## Appendix E - Part 2

### Agency, Developer, Public Correspondence

The Region is undertaking a Municipal Class EA Study for improvements to Warden Avenue and Kennedy Road from Major Mackenzie Drive to Elgin Mills Road, following the recommendations of the Region's 2016 Transportation Master Plan (TMP). Through the Study, York Region will review traffic operations and the need for transportation system and infrastructure improvements, including active transportation, on Warden Avenue and Kennedy Road from Major Mackenzie Drive to Elgin Mills Road, City of Markham.

**AIR QUALITY ASSESSMENT**  
**SENSITIVE & CRITICAL RECEPTORS**  
**(WARDEN AVE.)**

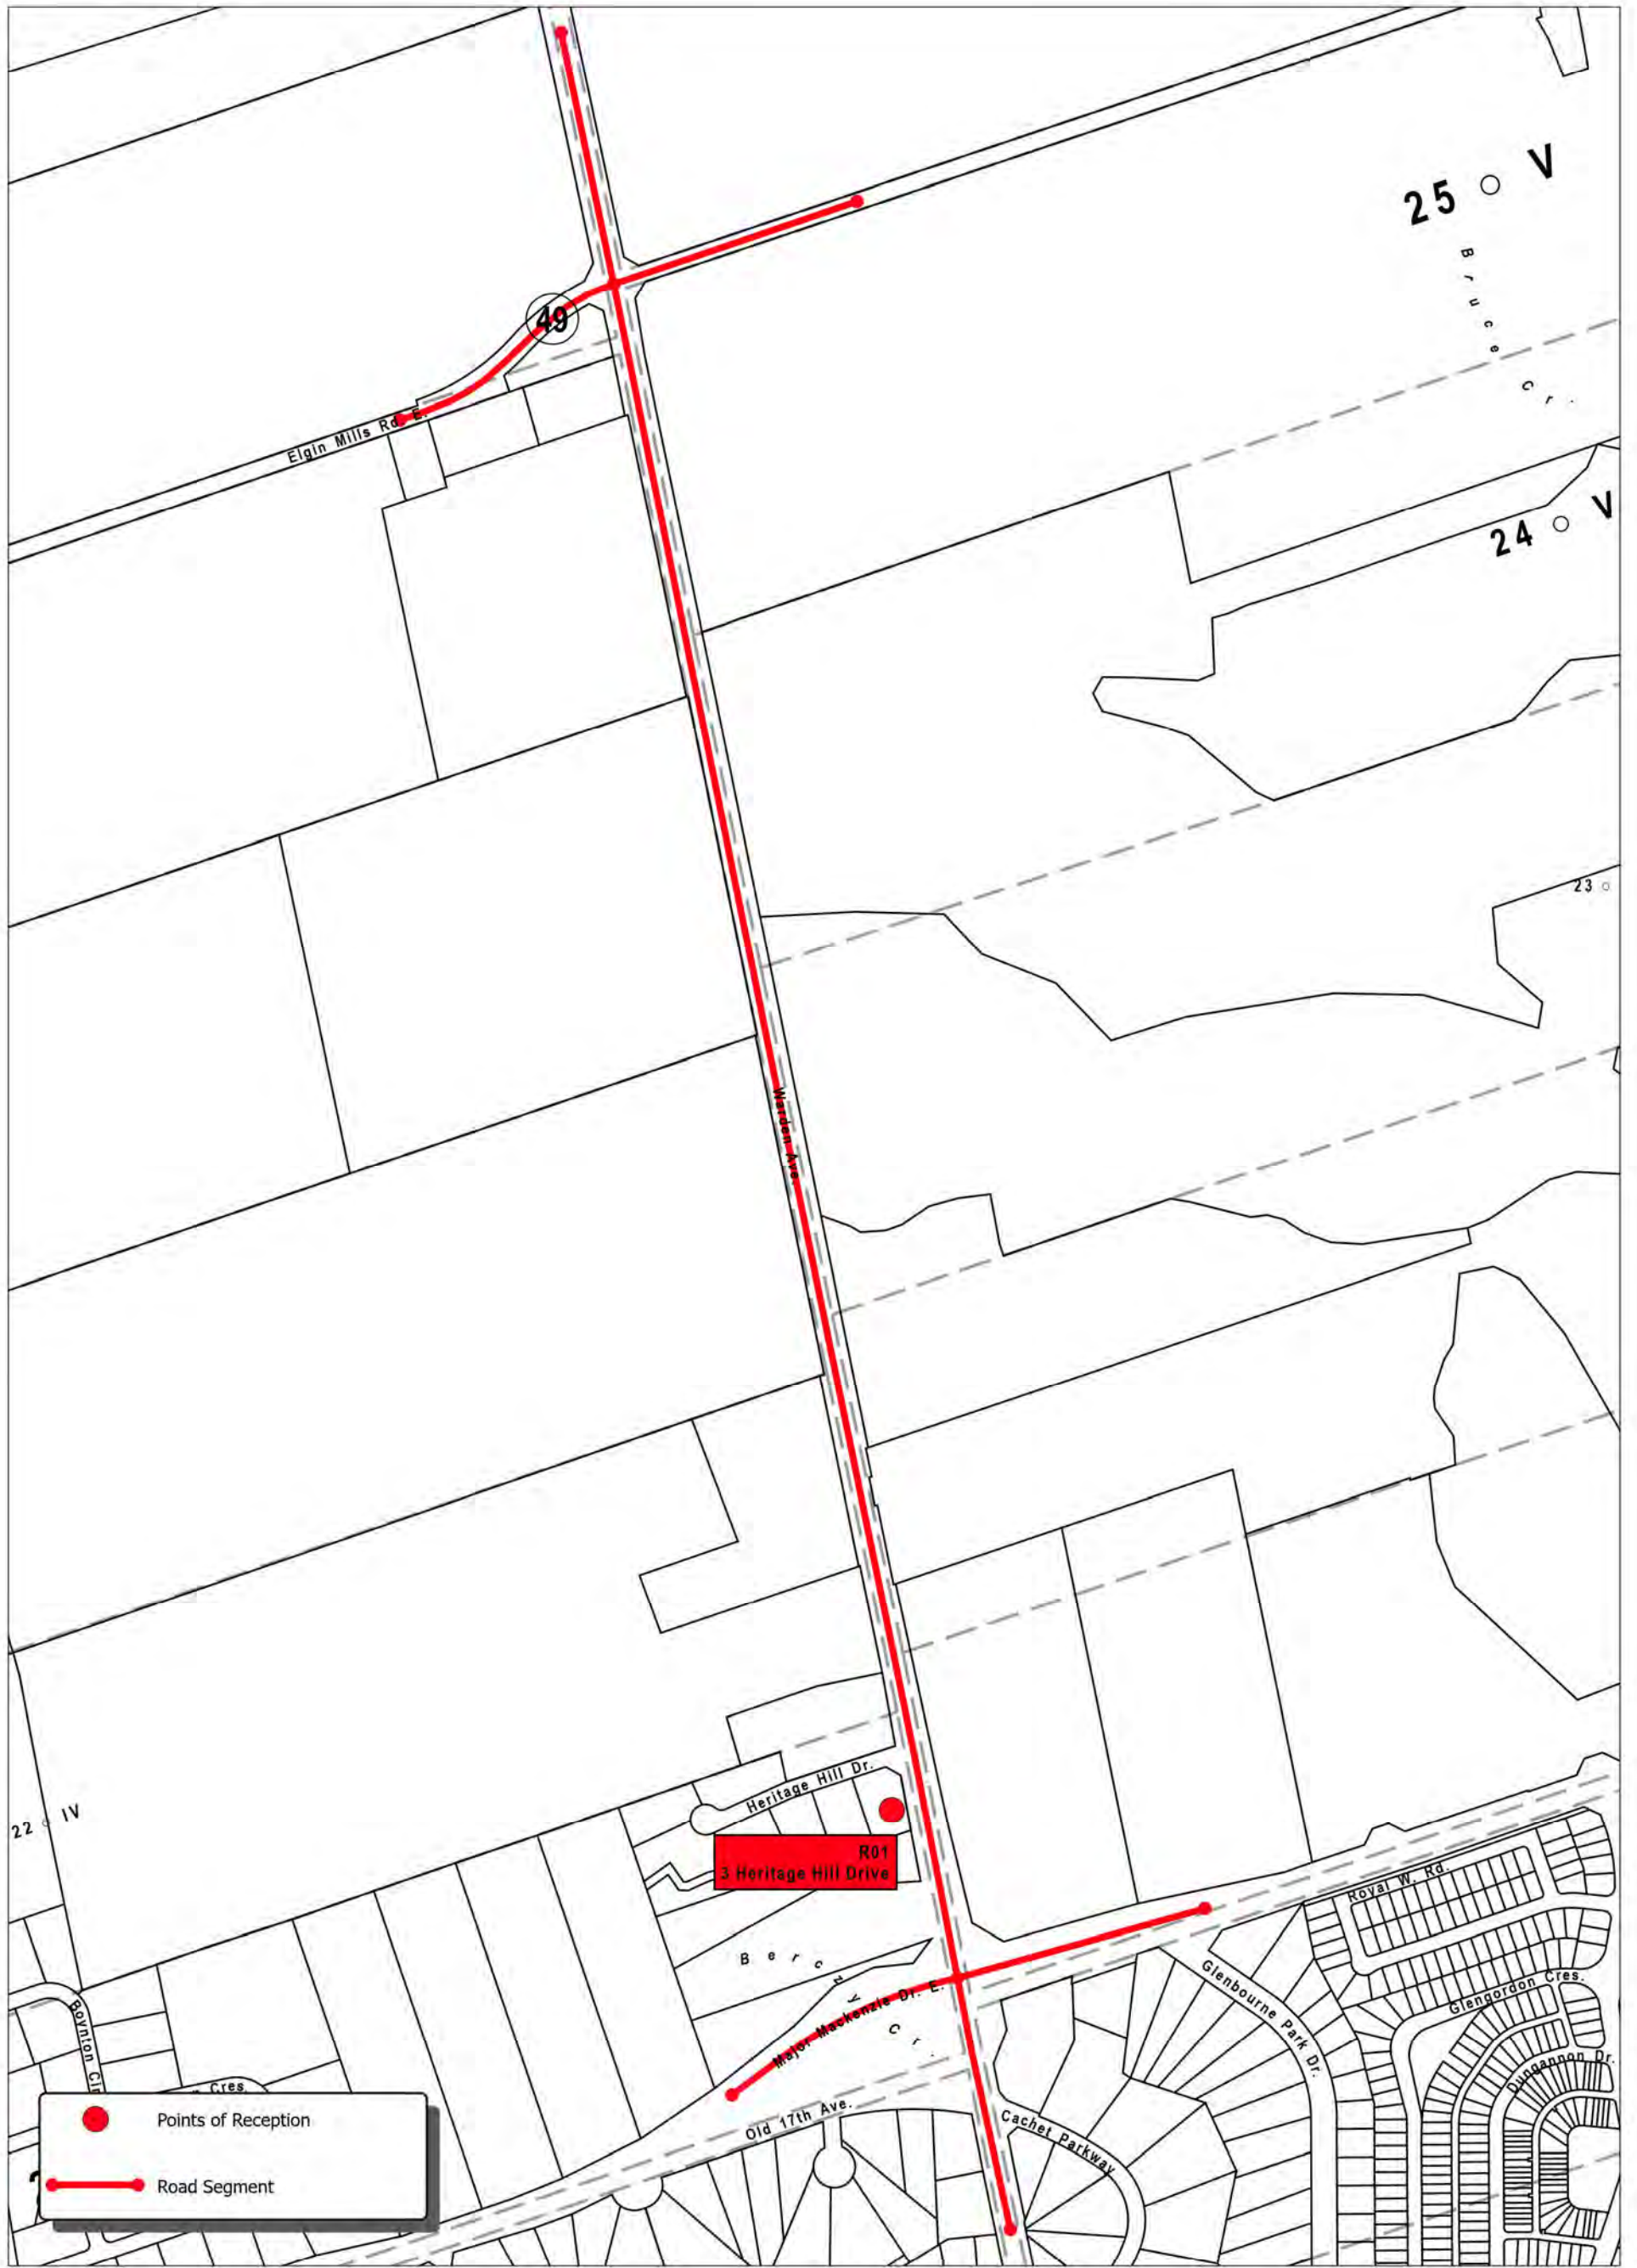
- MECP recommends one additional receptor at the intersection of Warden Avenue and Elgin Mills.
- The AQIA should provide rationale as to how the receptors identified were selected (i.e. closest to intersection, high traffic counts, etc.).
- If AERMOD is used, the approved model version is 19191.

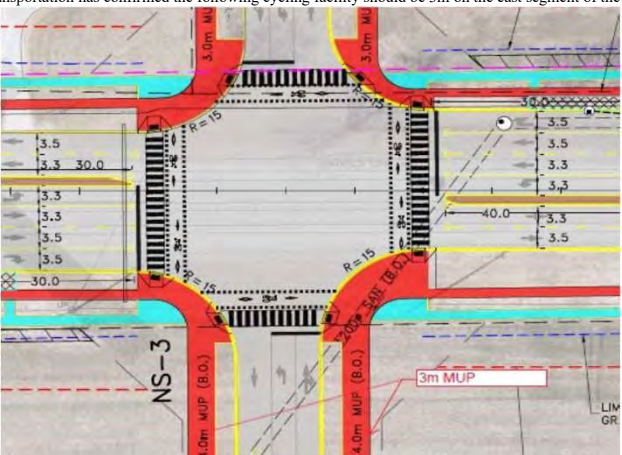
025	PIC #2 - Follow up	Transportation	Regarding comment #20 response	EW-1 is a major collector road consisting of four lanes through the intersection. This is not shown in the preferred design for Warden Ave.	
026	DRAFT ESR	Urban Design	LID features	Please consider extending LID features wherever possible. Example below 	
027	DRAFT ESR	Urban Design	LID features	Confirm whether bioswales are proposed. If so, include a cross-section that shows bioswale treatments	
028	DRAFT ESR	Urban Design	LID features	Identify locations of box trenches and bioswales on plans.	
029	DRAFT ESR	Urban Design	MUP Width	Transportation has confirmed that 4m MUPs will be proposed on the west segment of the EW-1.

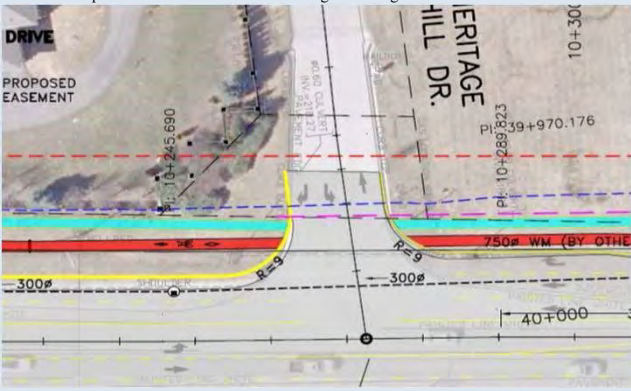
030	DRAFT ESR	Urban Design and Transportation Engineering	Cycling Facility	<p>Transportation has confirmed the following cycling facility should be 3m on the east segment of the NS-3.</p> 	
-----	-----------	---	------------------	---	--
